Access Compliance Report

Public Rights-of-Way

(Curb Ramps)

Intersection ID: 3156	Main Street: ASHBURTON_DR	Cross Street: STEWART_SPRING_LN	Location:	N/A
ADA ID: 9215D651FEED	Ramp Type: Perp	Initial Pass/Fail: Fail	Overall Compliance: No	Severity Score: 13.75
Codes/Mitigation Info/Possible Solution		Field Measurements/Component Compliance

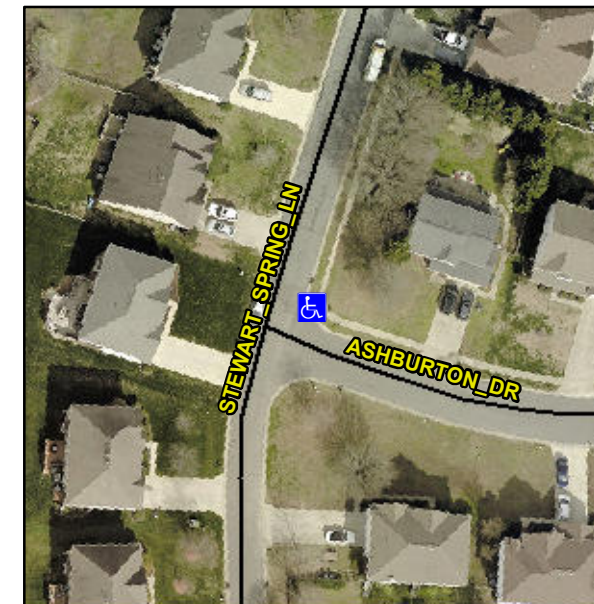
Remove & Replace Entire Ramp.

R304.2.2, R304.5.3
